City of Fond du Lac

2024-096 Food Hall 8/30/2024 Addendum #1

This addendum is being issued to share all questions that have been received to date and give the answers to all plan holders.

Sheet Contents
VERTICAL
CIRCULATION
PLANS

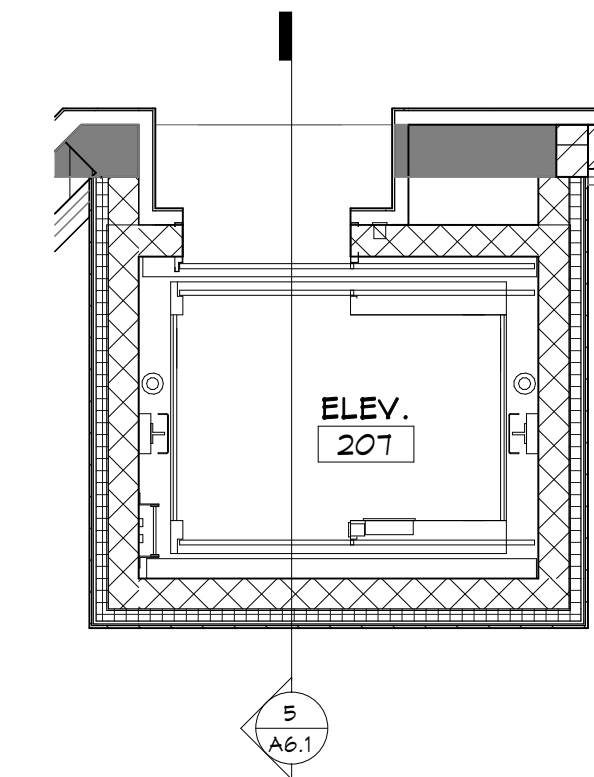
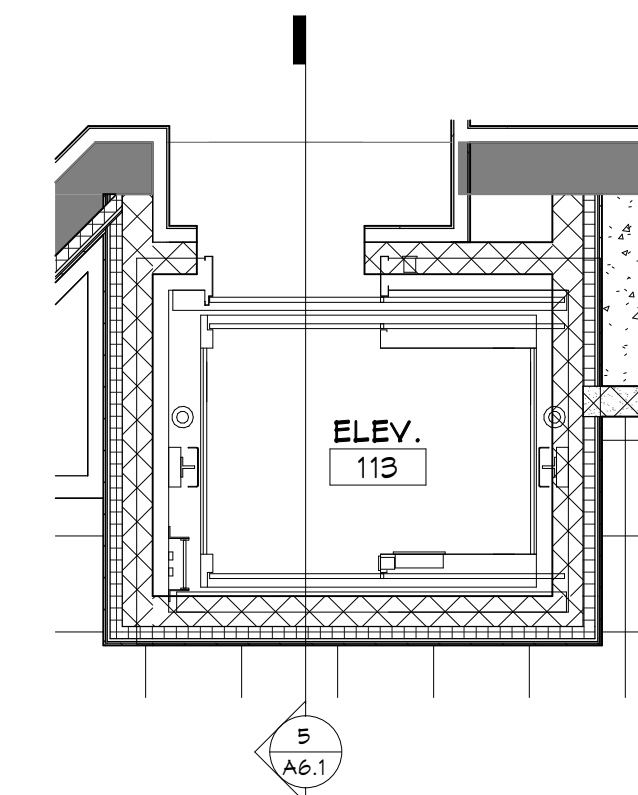
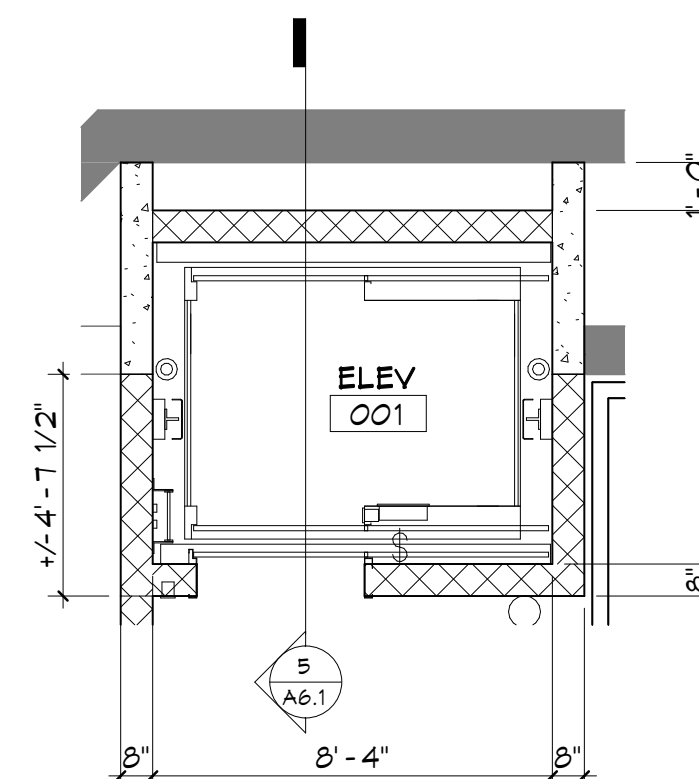
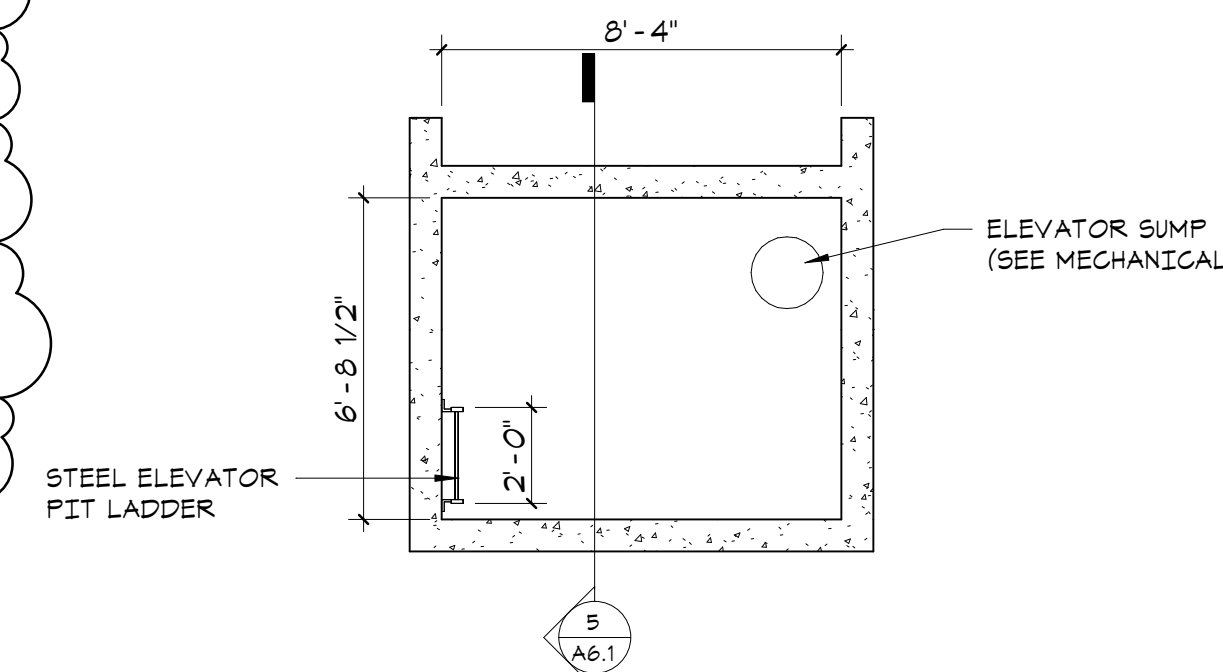
- a. The condition shown at the first floor in detail 3/S1.1, shows a concrete slab with thickened edge. Sheet S2.1 shows wood framing. Please advise which is correct and if possible, provide a more detailed section cut detail.

- i. This has been revised. See sheets A6.1 and S1.1 included with this addendum.
 - b. Can you provide a full detail of the structural condition at the second floor where we extend the floor to the elevator shaft? Detail 3/S2.2 only shows partial.

- i. This has been revised. See sheets A6.1 and S2.2 included with this addendum
 - c. All details on S1.1 seem to show dowels from the stem wall into existing foundation walls. Details 1&2/S2.1 do not show dowels. Please advise if dowels are needed and if so, what type, size, OC spacing.

3 SECTION
S1.1 SCALE: 1/4" = 1'-0"

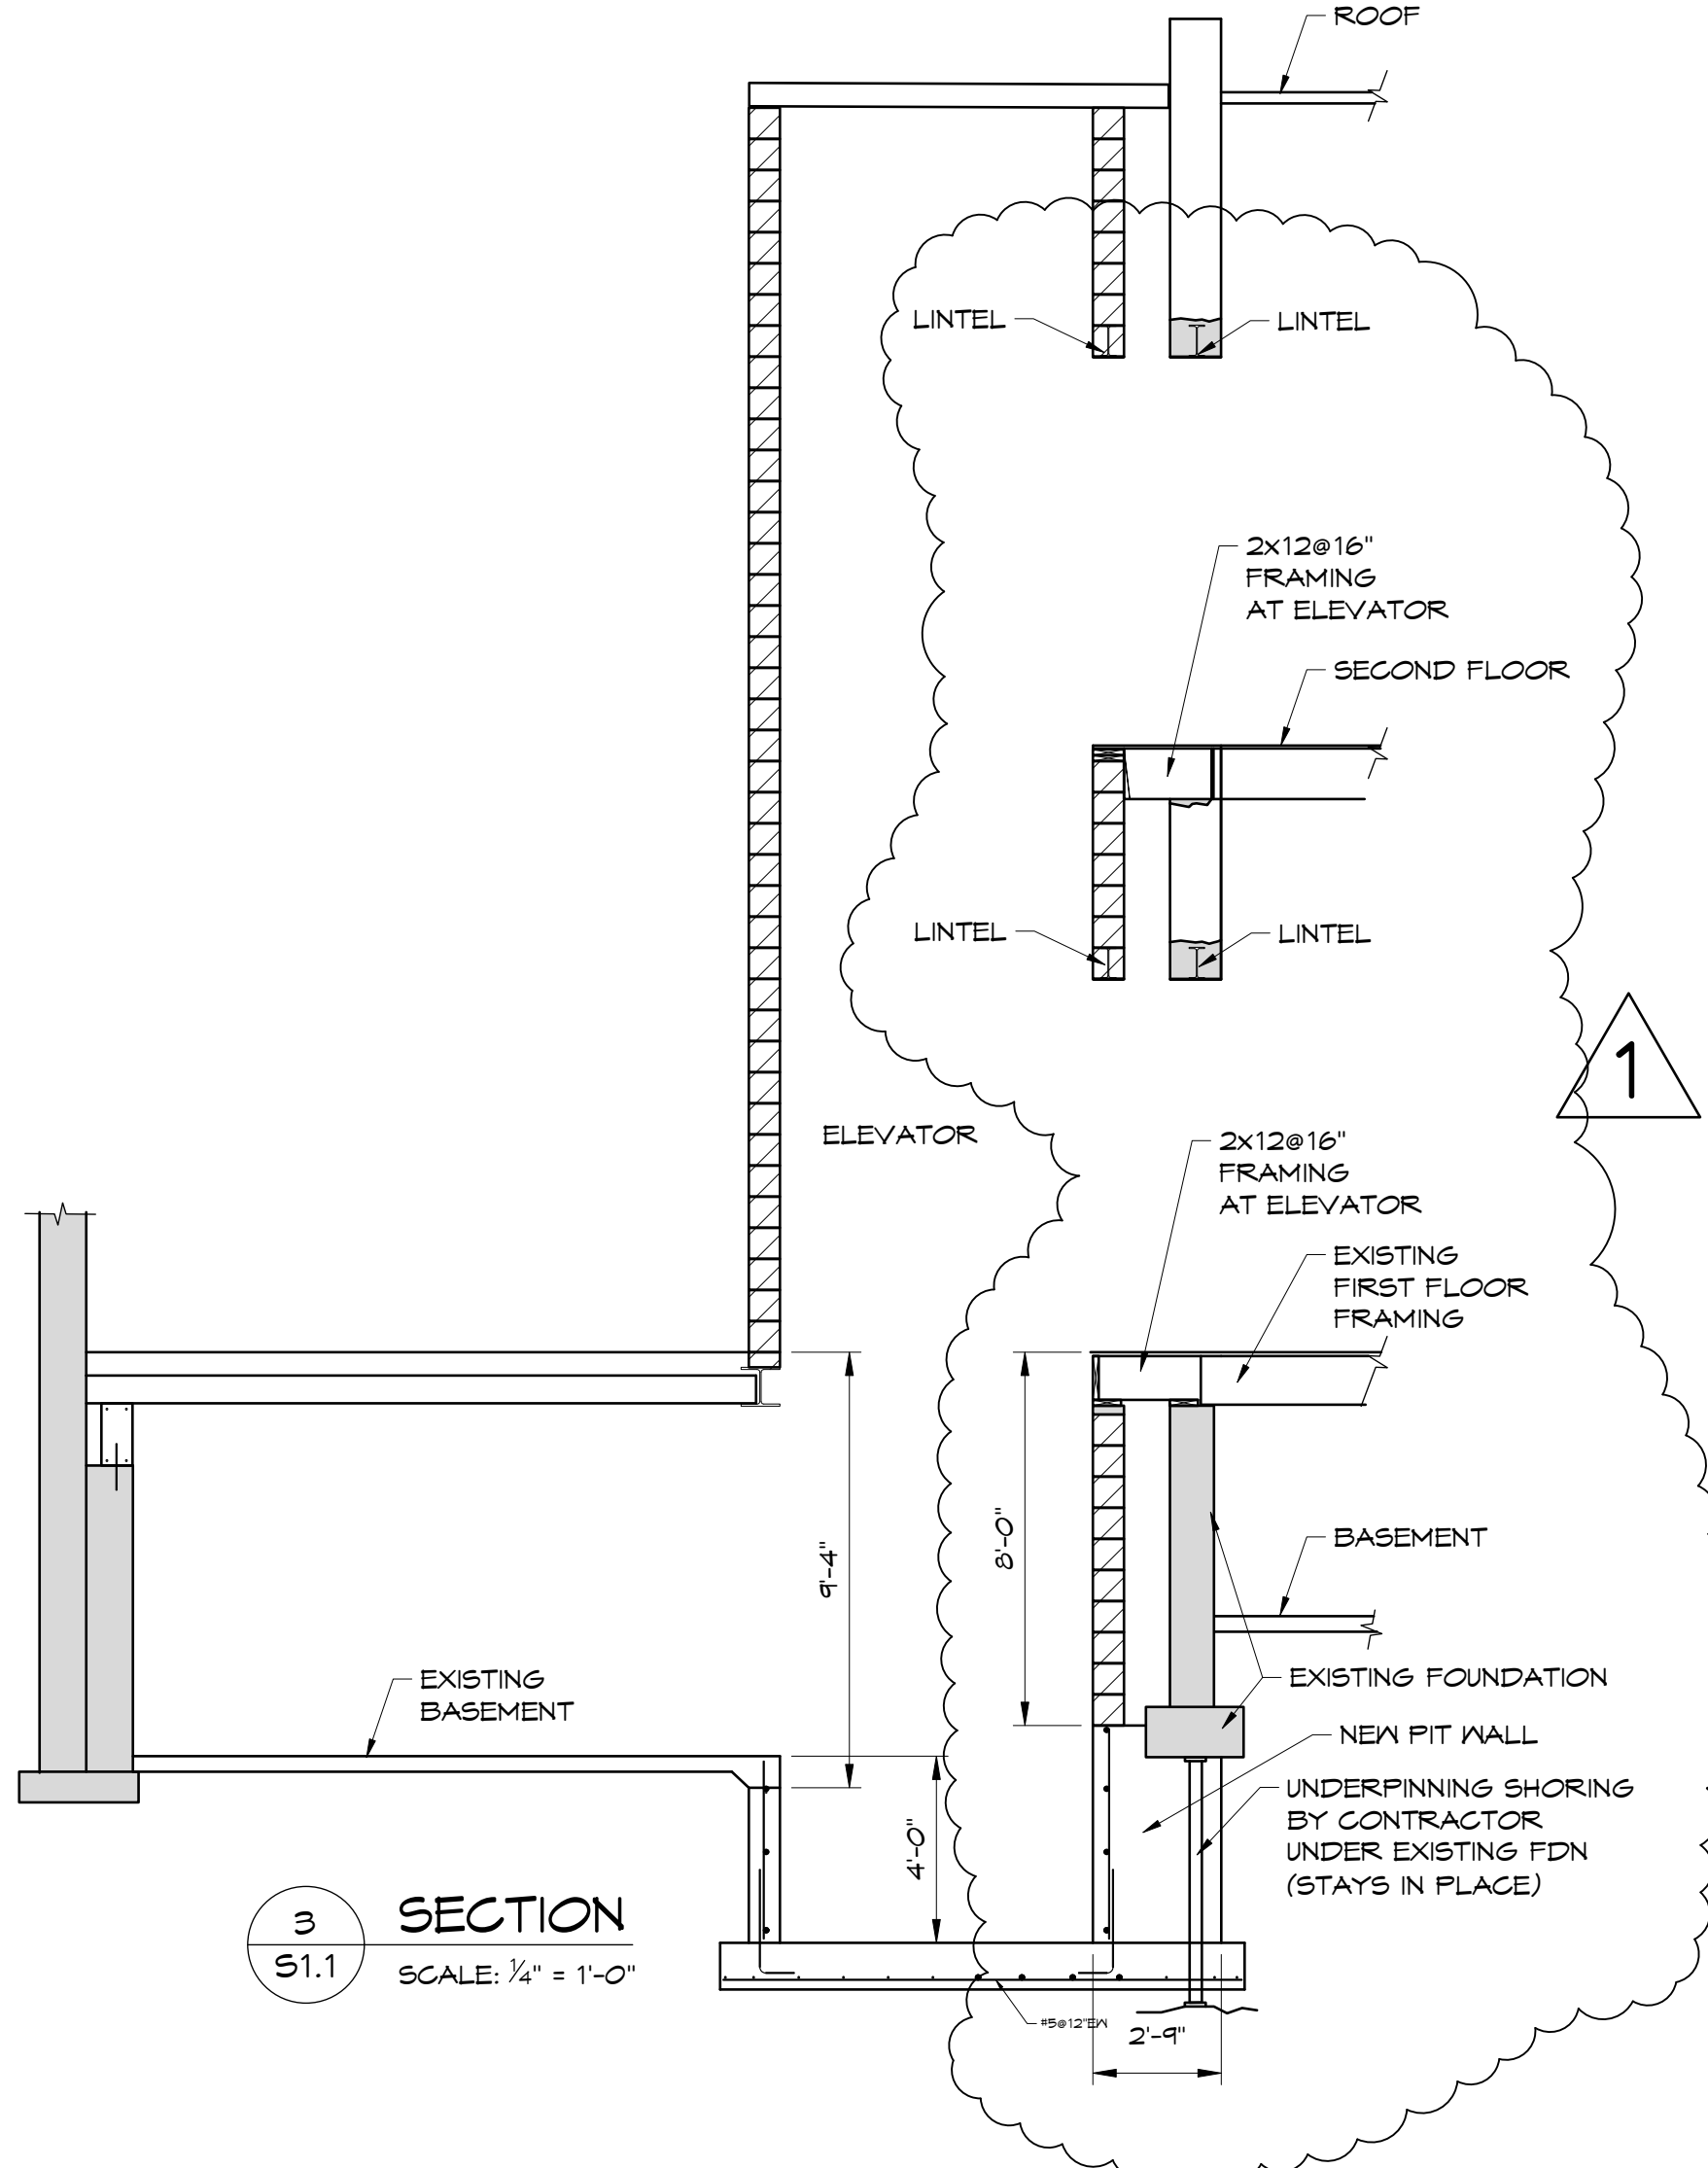
- Sheet S1.1 – Existing walls are shaded except for on detail 3. I assume the footing shown above the elevator pit, furthest to the right, is existing and will need to be underpinned in order to pour the new pit? Is there a detail for this?

SECTION 1
SCALE: 1/2" = 1'-0"

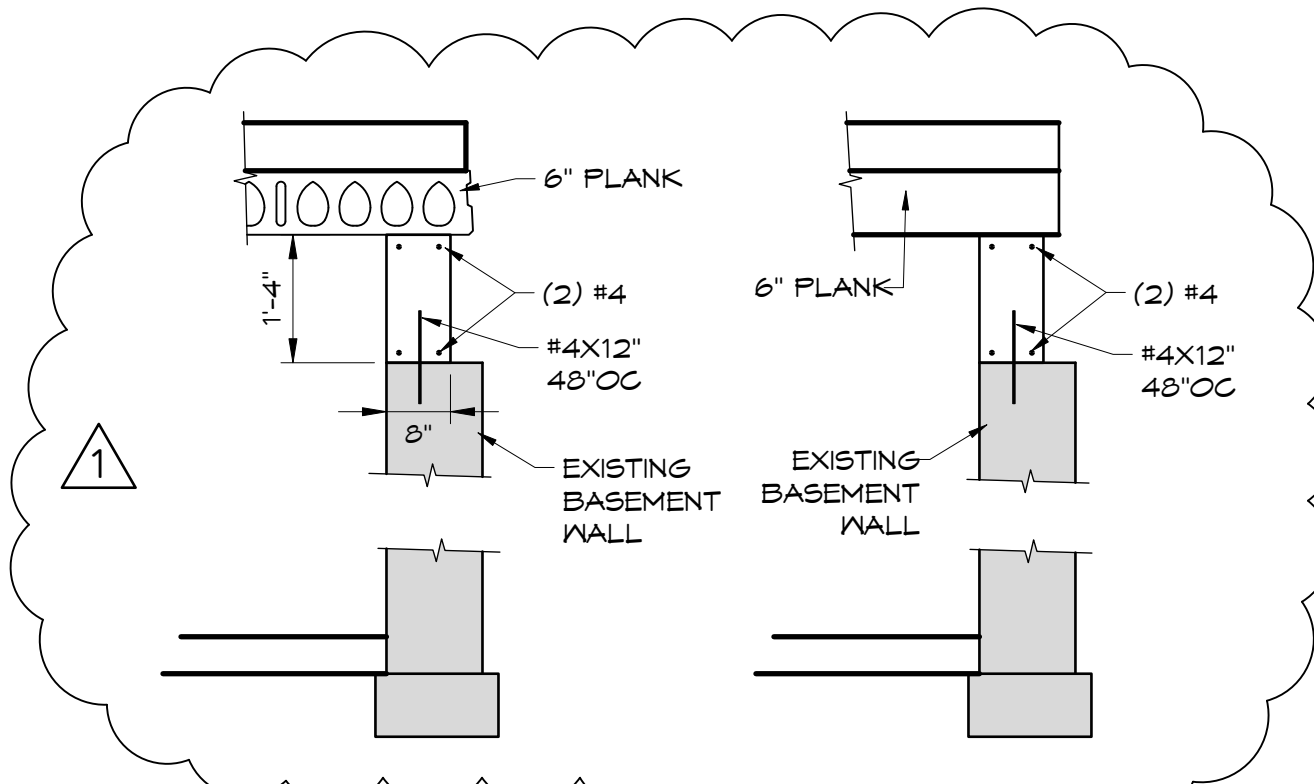
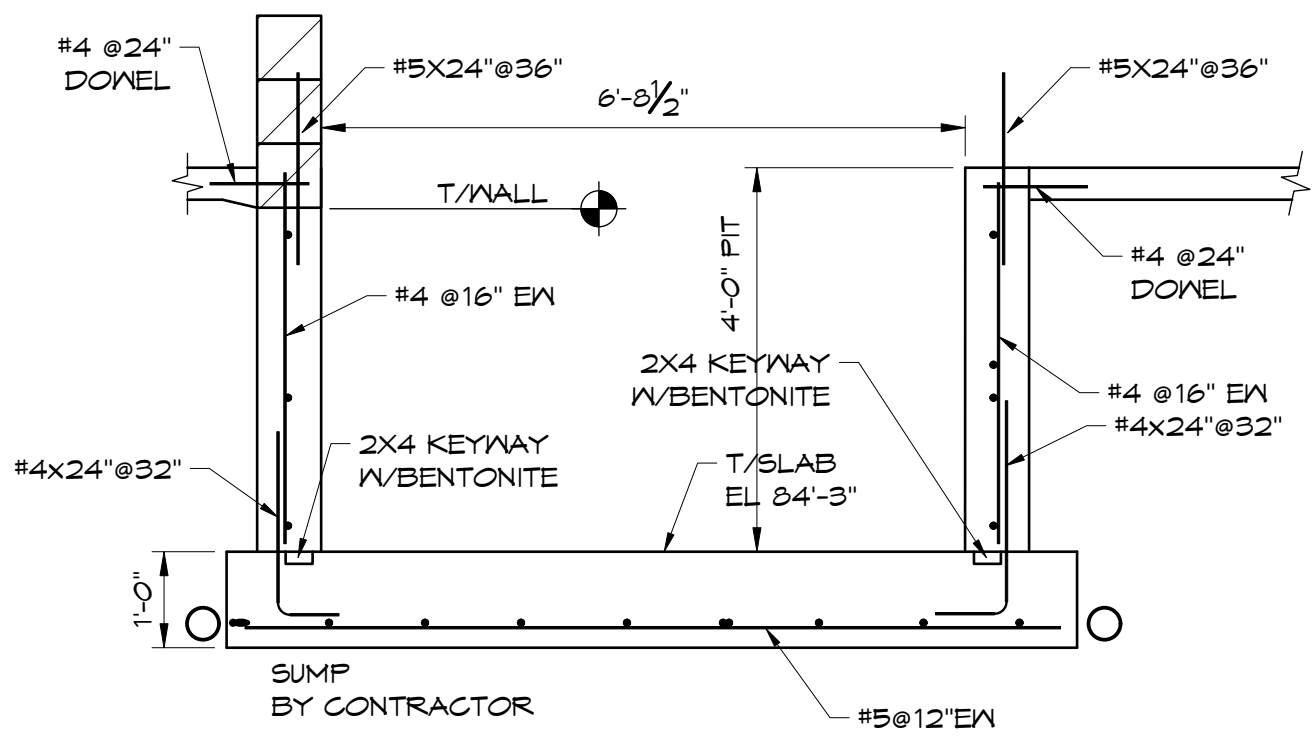
- i. This has been revised. See sheets S1.1 and S1.2 included with this addendum
- Sheet S2.1 – Can you please provide footing size and required reinforcing for the strip footing and column pad?

- This has been revised. See sheets S2.1 included with this addendum
 - Sheet A2.3 – Note D2 states to remove portion of existing wall for new construction. D2 is used at all existing windows on the second floor. I assume this is an error and we are removing only the existing windows and prepping for new windows?
